FPL Energy
Seabrook Station

SBK-L-06059
Docket No. 50-443

Seabrook Station
License Amendment Request 06-03
“Application for Amendment to the Technical Specifications
for Miscellaneous Changes”

License Amendment Request 06-03

Referenced Drawings and Service Water Pumphouse Level Graph

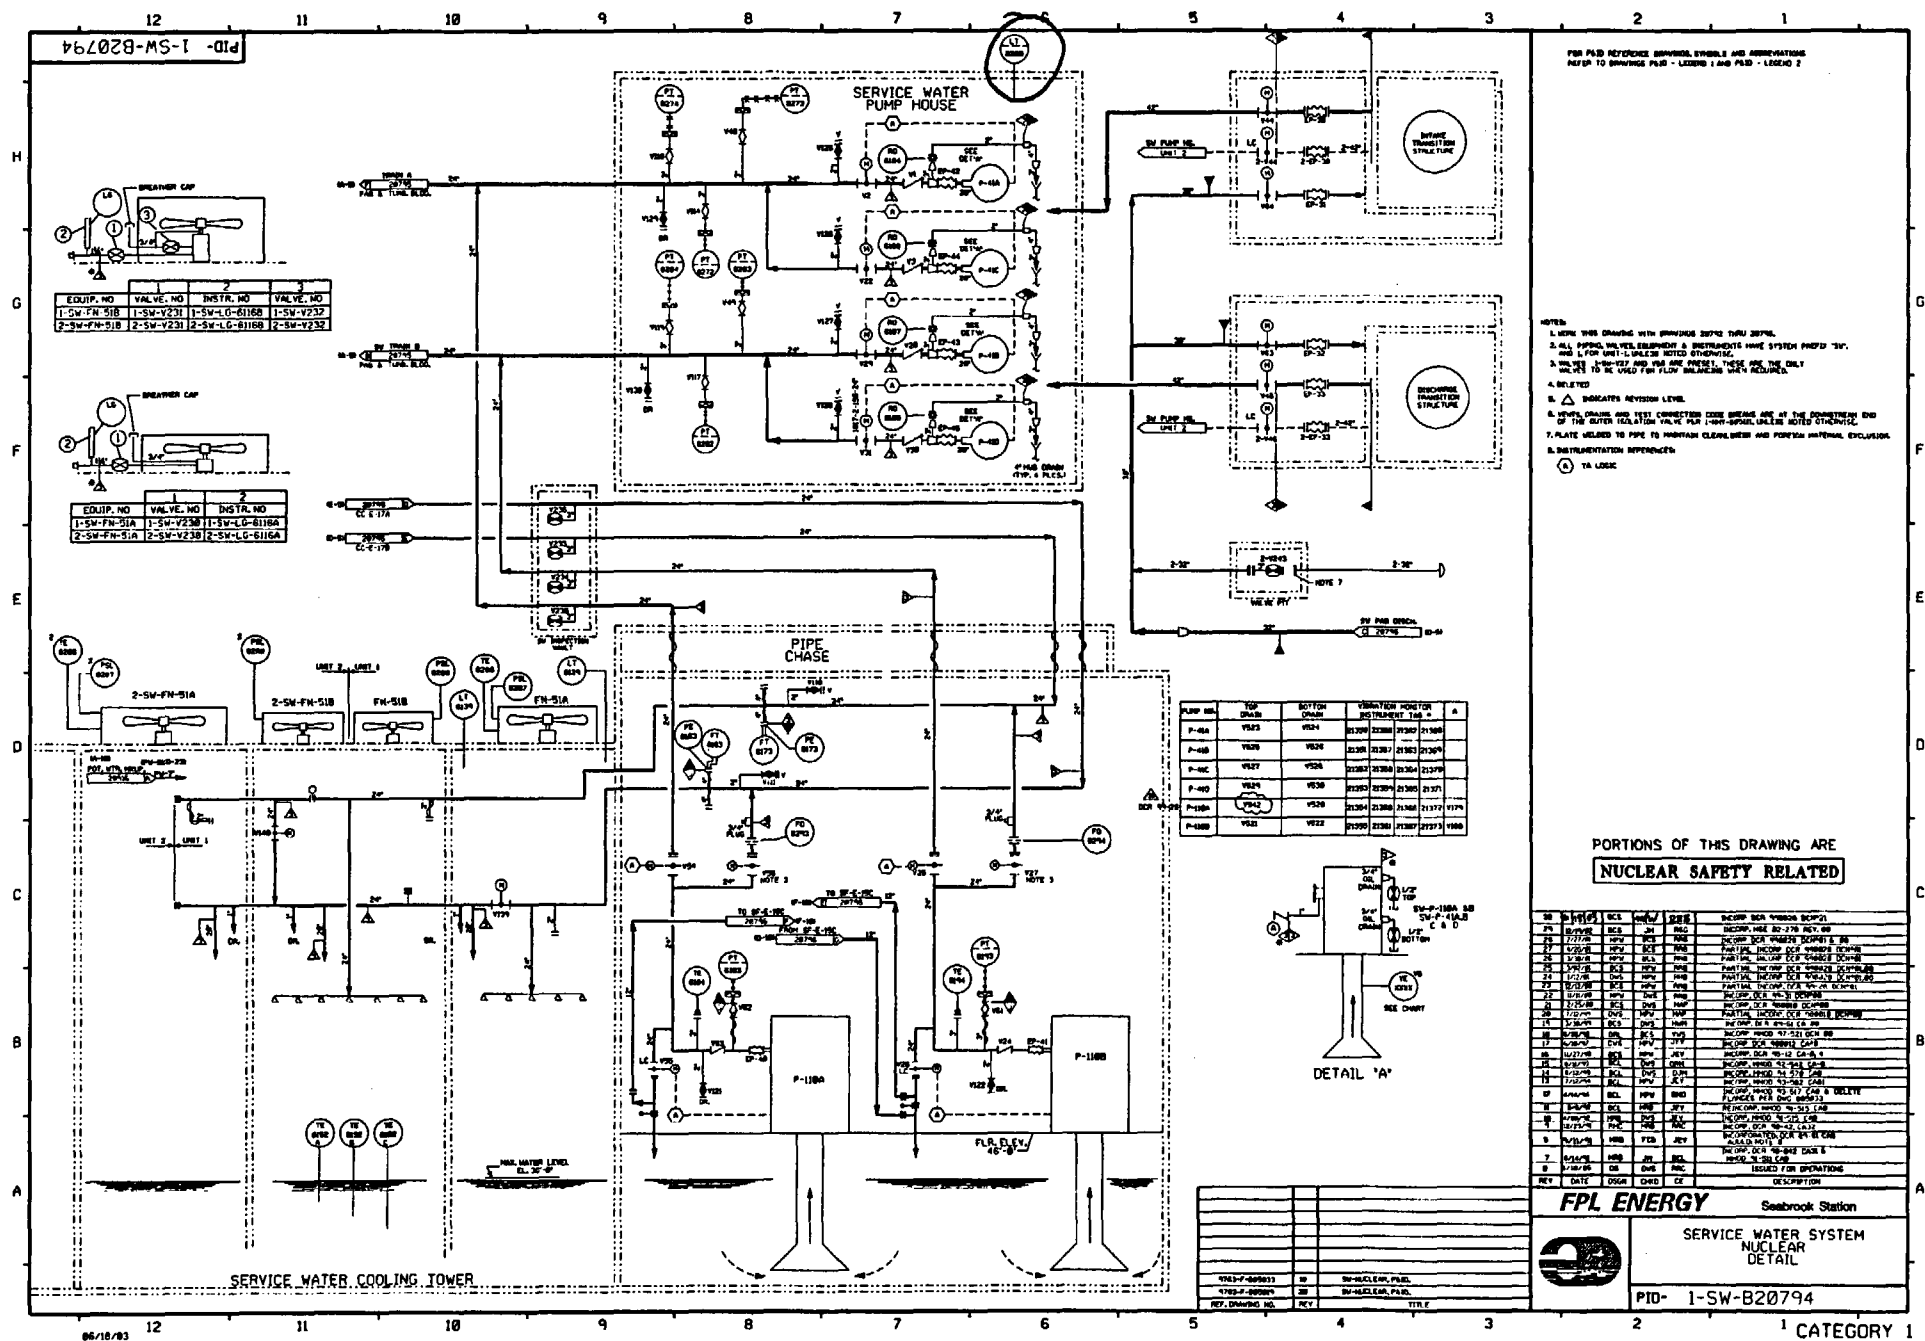
TS Surveillance Requirement 4.7.4.3 calls for the service water pumphouse water level to be verified at or above 5'0" (-36'-0" Mean Sea Level) at least once per 24 hours. This level is not adequate to support service water pump operation and is therefore not correct. The inadequate level stated in the surveillance was identified in 1997 and administrative controls put in place to verify adequate pumphouse water level. The Control Room TS log has operators verify, daily on the Operations TS Logs, that the service water pumphouse level is greater than 25 feet.

3/4 7-13A	In Surveillance Requirement 4.7.4.3, replace 5'0" (-36'-0" Mean Sea Level) with 25.1' (-15.9' Mean Sea Level).

SERVICE WATER SYSTEM
NUCLEAR
DETAIL

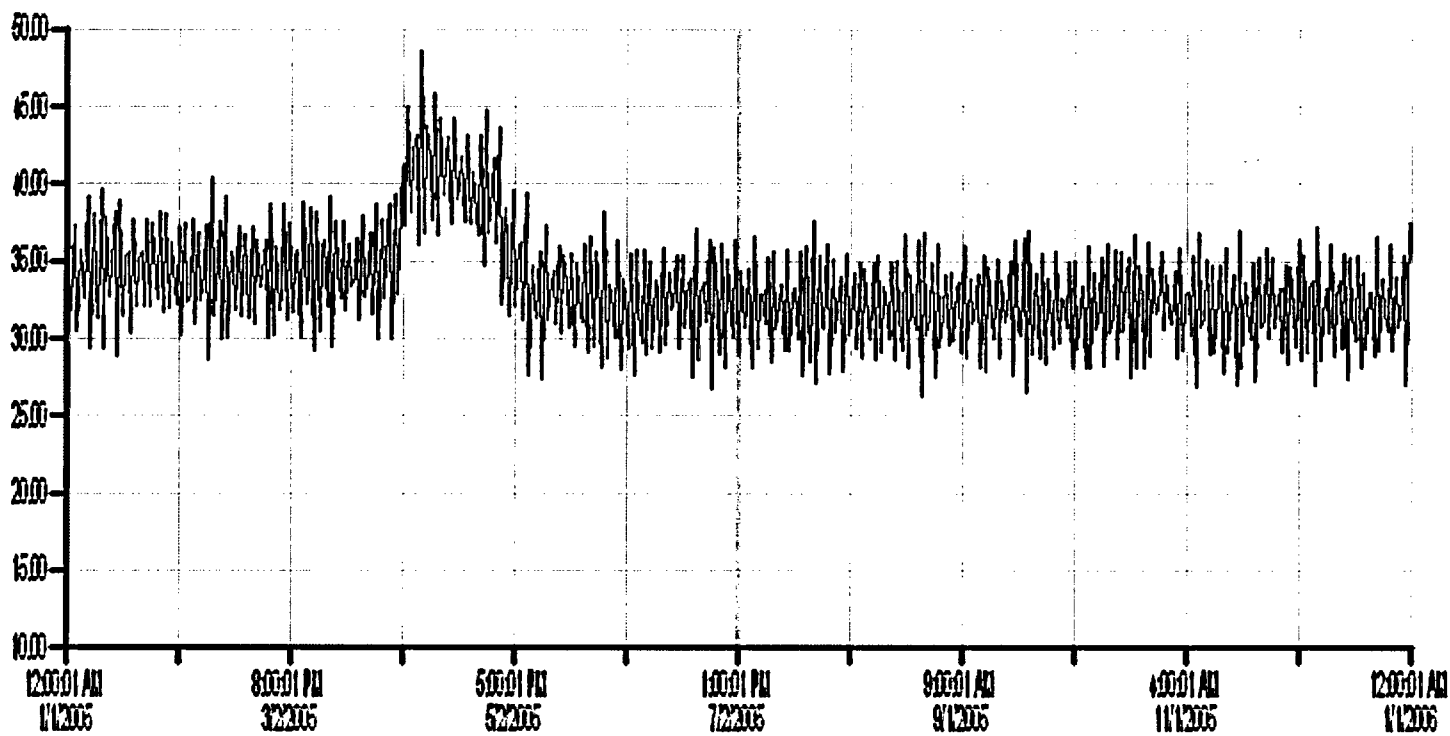
Calculation 4.3.08.72F, Attachment 1, indicates (page 133) that the minimum service water pumphouse level to support service water system operation is (-)15.9' Mean Sea Level (MSL). Calculation 4.3.08.36F indicates (Appendix A, page 4) that the 0' indication for this instrument is (-)41' MSL. The required indicated level is therefore 41' (*i.e.* MSL) - 15.9' = 25.1'. The proposed change corrects the minimum pumphouse level error.
